ADDENDUM NUMBER ONE 10/26/2018

PROJECT: TOWN OF POMARIA RECERATION RENOVATIONS – 3606.1704
138 FOLK ST.
POMARIA, SC 29126

FROM: Johnson, Laschober & Associates, P.C.
1296 Broad Street
Augusta, GA 30903
(706) 724-5756

DRAWING NO. **M-101** REV. **1**

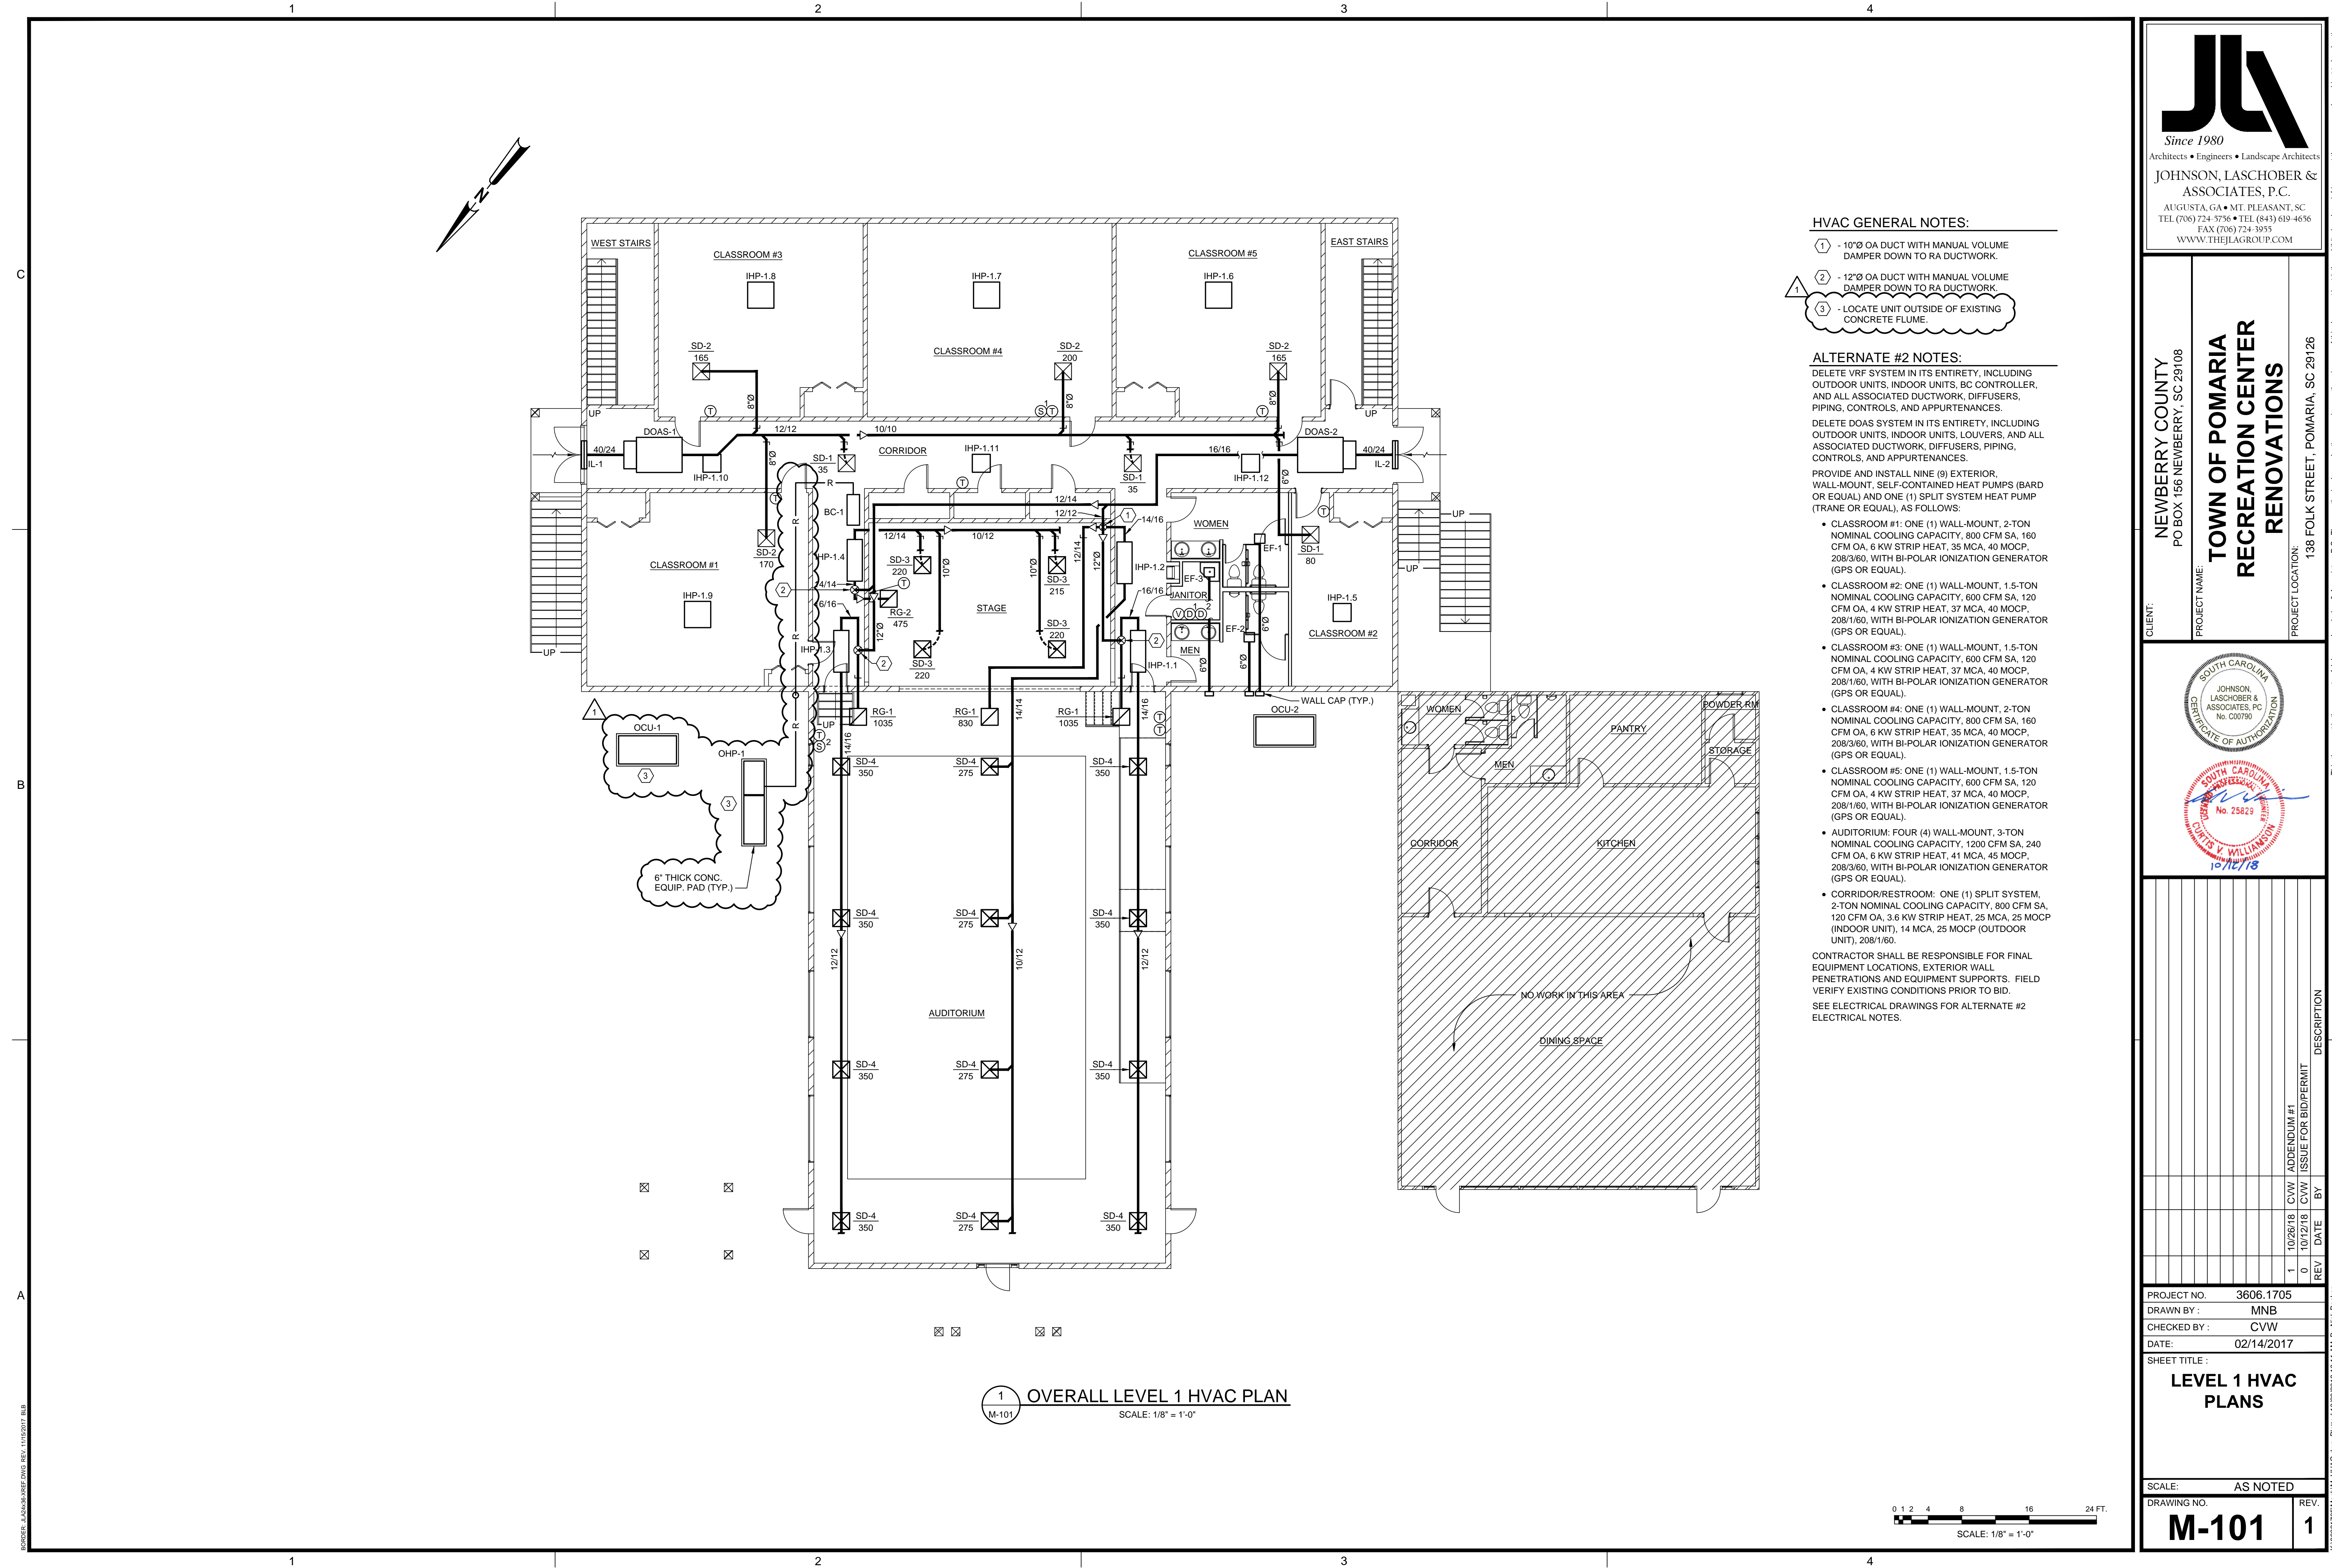
11. Work Restrictions (011000-1.8) have been updated and modified. See Specification 011000, "Summary" for all changes.
12. Placement of OCU-1 and OHP-1 will be in the grass area outside of the existing concrete flume. See M-101 & E-201 for details.

DELETE VRF SYSTEM IN ITS ENTIRETY, INCLUDING OUTDOOR UNITS, INDOOR UNITS, BC CONTROLLER, AND ALL ASSOCIATED DUCTWORK, DIFFUSERS, PIPING, CONTROLS, AND APPURTENANCES.

DELETE DOAS SYSTEM IN ITS ENTIRETY, INCLUDING OUTDOOR UNITS, INDOOR UNITS, LOUVERS, AND ALL ASSOCIATED DUCTWORK, DIFFUSERS, PIPING, CONTROLS, AND APPURTENANCES.

PROVIDE AND INSTALL NINE (9) EXTERIOR, WALL-MOUNT, SELF-CONTAINED HEAT PUMPS (BARD OR EQUAL) AND ONE (1) SPLIT SYSTEM HEAT PUMP (TRANE OR EQUAL), AS FOLLOWS:
